SOUTH WEST MILTON KEYNES

Appendices to Rebuttal Proof of Evidence re MKC of Martin J Paddle BSc CEng CWEM MICE FCIHT MCIWEM, in regard to Transport, Highway and Accessibility Matters: PINS ref: APP/Y0435/W/20/3252528 LPA ref: 15/00619/FUL

OUR REF. NO. SWMK: APPENDICES TO REBUTTAL PROOF OF EVIDENCE RE MKC OF MARTIN J PADDLE

DATE: 27 APRIL 2021

Figure 1: Forward visibility onto pedestrian crossing

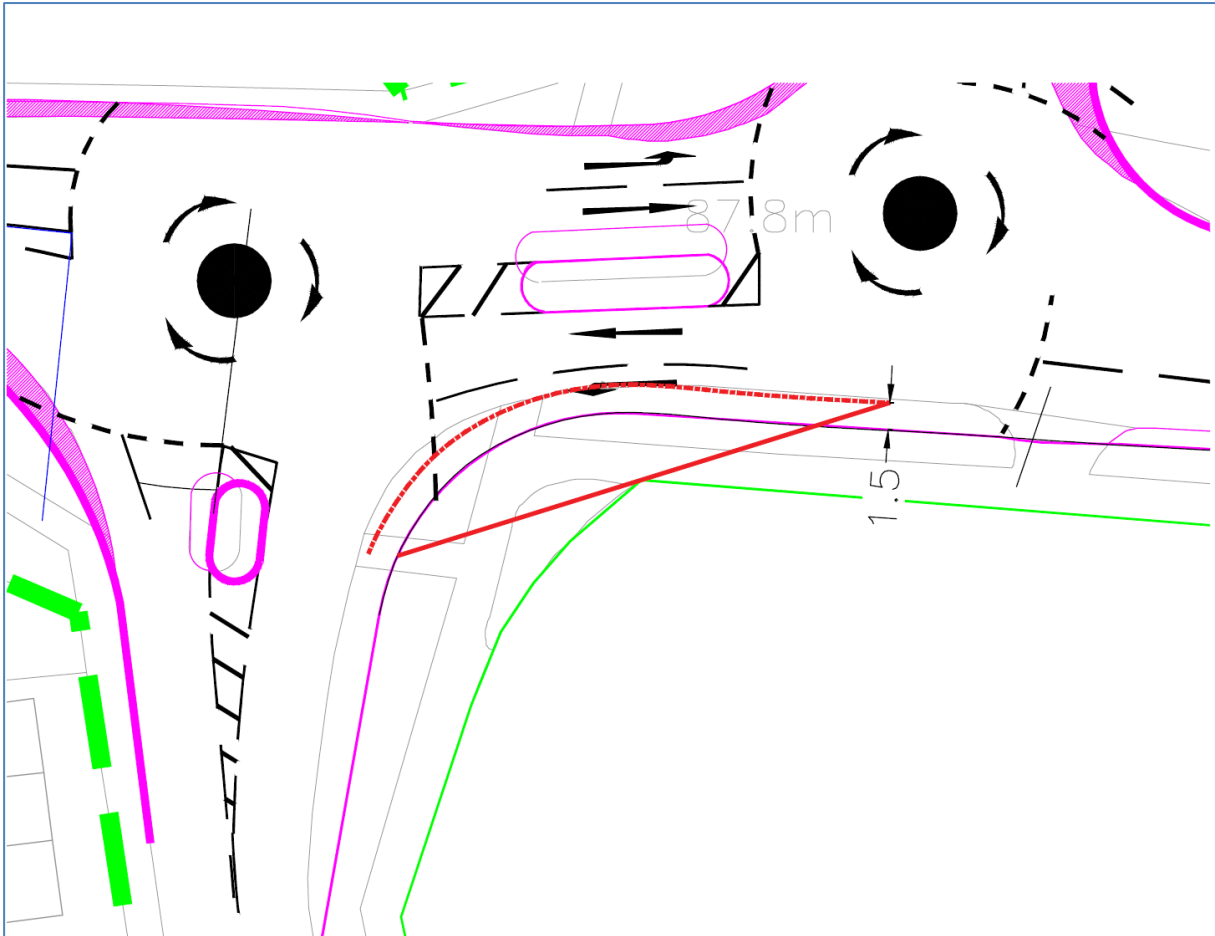
Under the proposals, the approach from Newton Road (southern arm) aims drivers in the right hand lane directly at the central island. This could make manoeuvring around the island difficult.

The forward visibility to pedestrians waiting to cross on the eastern side of Newton Road is worsened by the proposals. Taking an MfS SSD (given the speeds and environment), there is currently space to accommodate an approximately 41.9m SSD to the centre of the footway at the crossing. Under the proposals this is reduced to approximately 31.9m (both distances measured along the driver's path), as shown below:

Figure 2: Roundabout exits blocked by HGVs

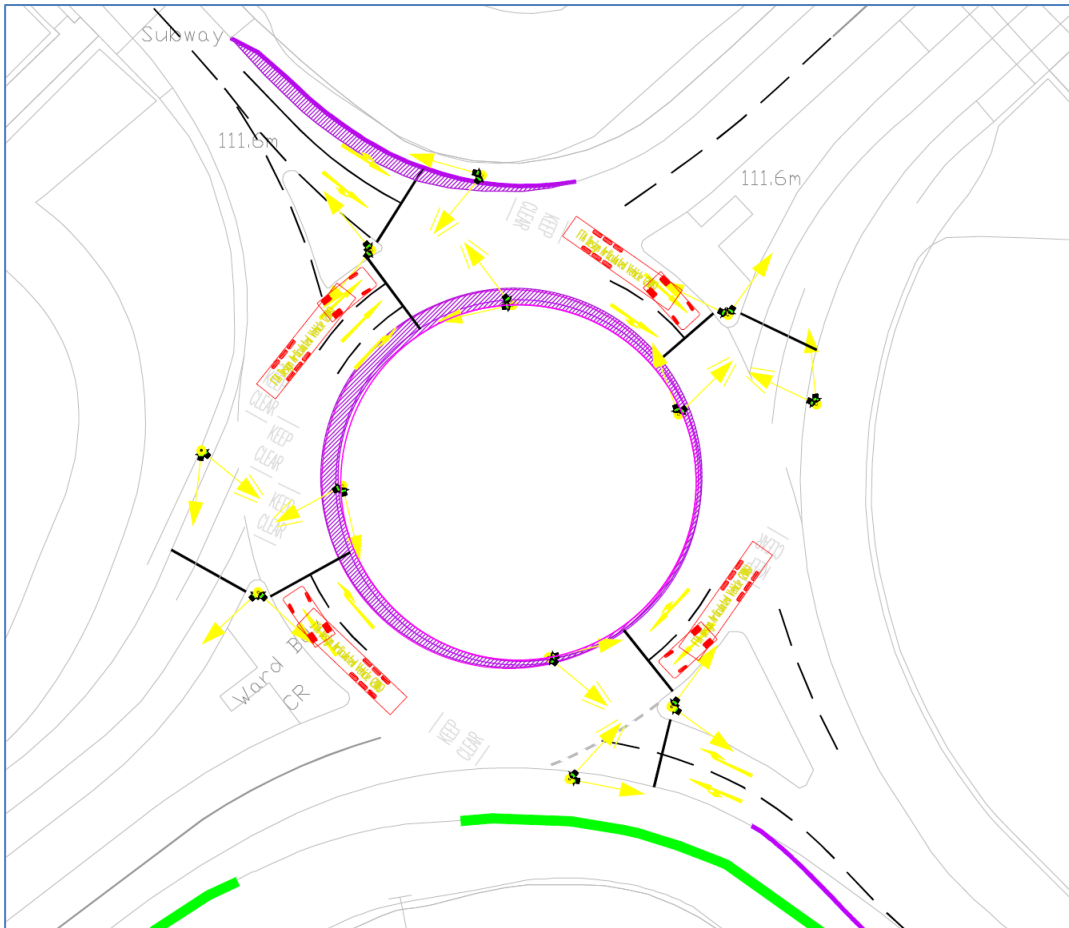
This has previously been discussed, and WSP has therefore provided an explanation at TRN3 paragraphs 5.2.11 and 5.2.12. WSP implies that blocking back is of no concern as the longest queue on the gyratory is 3.1 PCU before the lights turning green, when considering the back of a Uniform Queue (UQ) (Table 5.5 within TRN3). 3 PCU equates to approximately 17m of queuing from the stop line, and a corresponding stacking capacity of 16-20m has been provided. However, a fluctuation of one vehicle on the gyratory could cause blocking back and impact on the junction's operation, as a single PCU (5.75m) would exceed the provided stacking capacity.

The UQ does not allow for such variations, and is not the appropriate queue measure. LinSig models queue lengths in three components, of which UQ is one. The Mean Max Queue (MMQ) is an average of those three components, and provides a more realistic indication incorporating the random and oversaturated queues. Lanes 1 and 2 on the west gyratory have a MMQ of 6.3 and 6.7 respectively, which is in excess of 34m of queuing space.

In any case, an articulated HGV stopped at the lights would completely or partially block the exits of the roundabout as shown in Figure 2:

Keep Clear markings have been proposed to mitigate against this potential blocking back. Given that the junction is signalised and would be congested at busy periods, it is unlikely that these markings would be observed by drivers and they are not enforceable.
